ON-SITE SEWAGE DISPOSAL SYSTEM HOWARD COUNTY HEALTH DEPARTMENT BUREAU OF ENVIRONMENTAL HEALTH

SUBDIVISION: Brighton Mill LOT NUMBER: 1

MEMORANDUM

RE: Project Number: 2061
Title: Brighton Mill Lot # 1
Property Perc Certification Plan

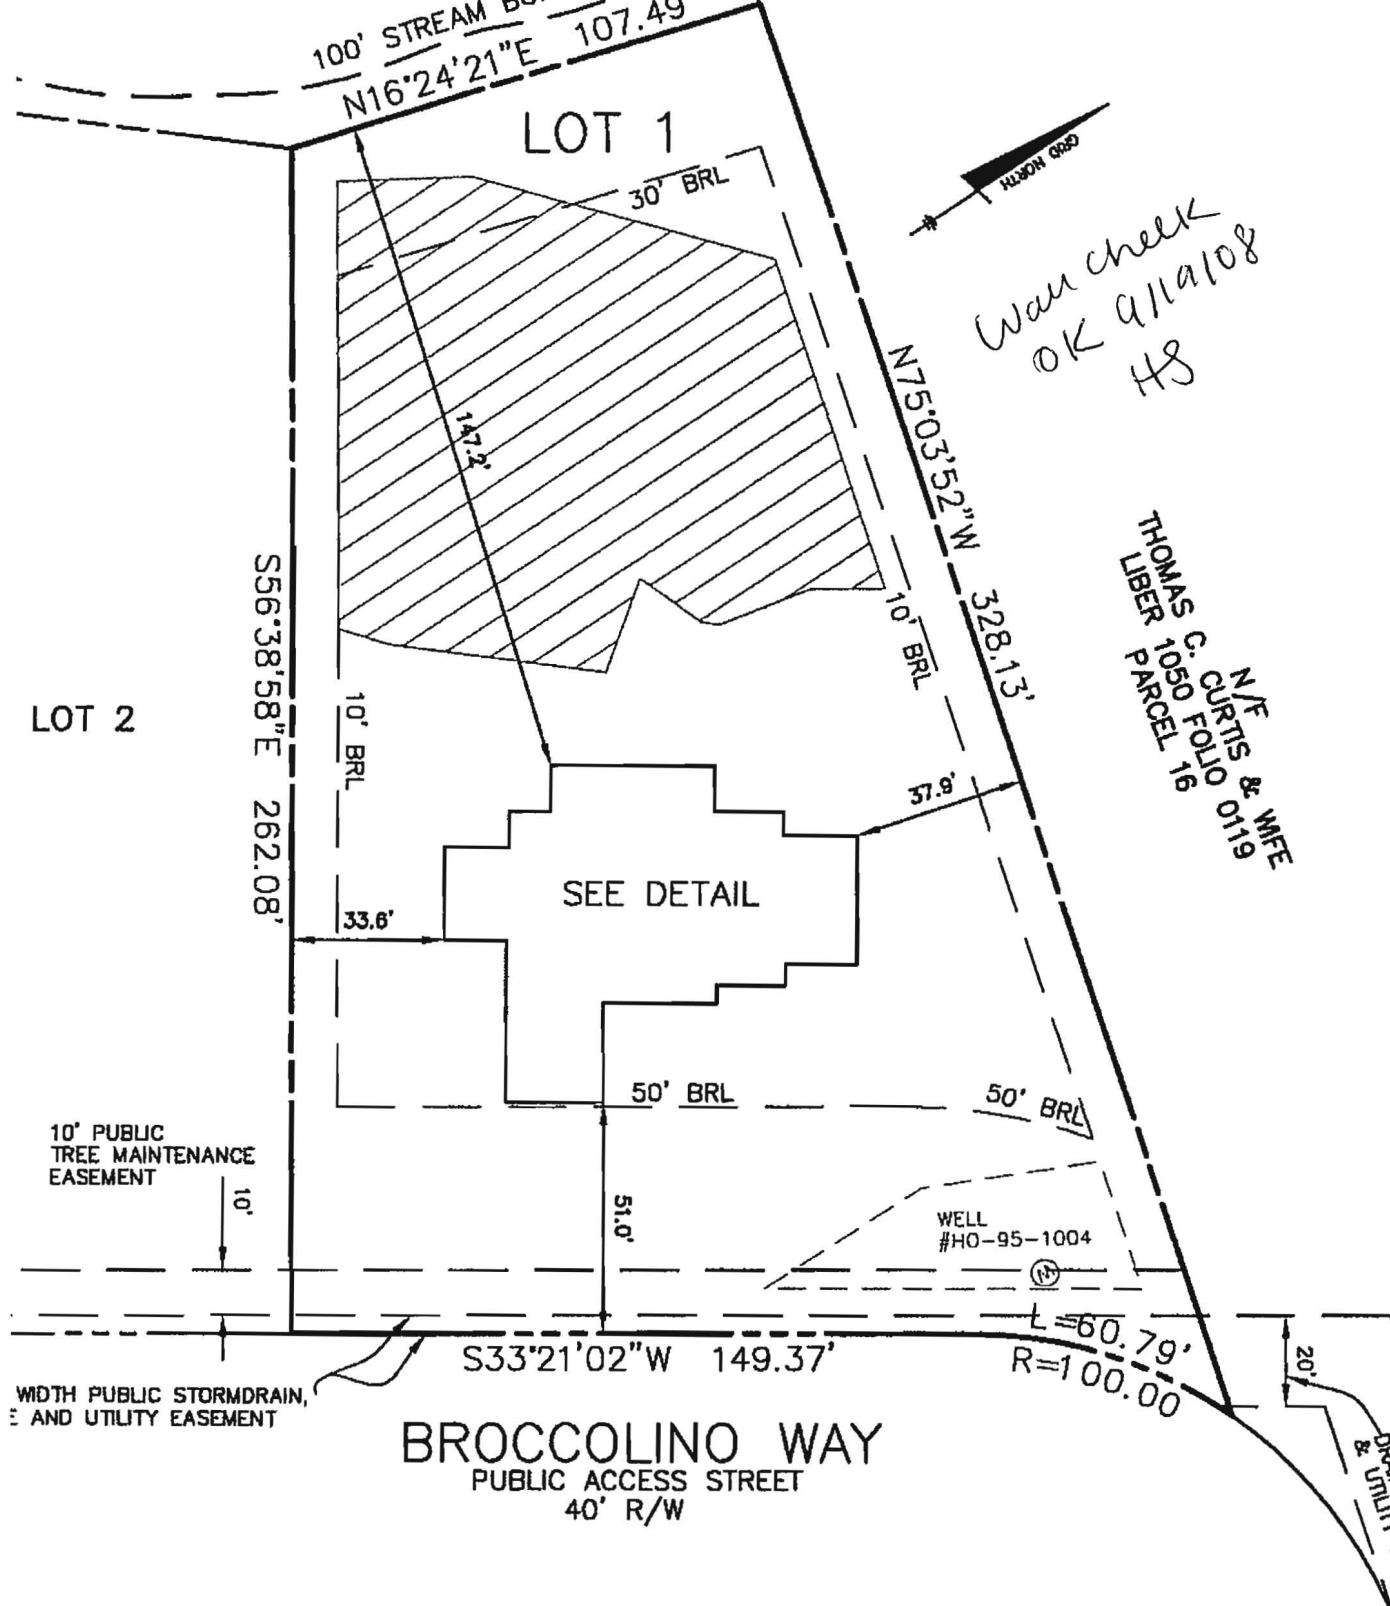
- Septic tank should be 20 feet from house foundation and 5 feet from the deck.
- Gazebo should be 5 feet from septic easement.
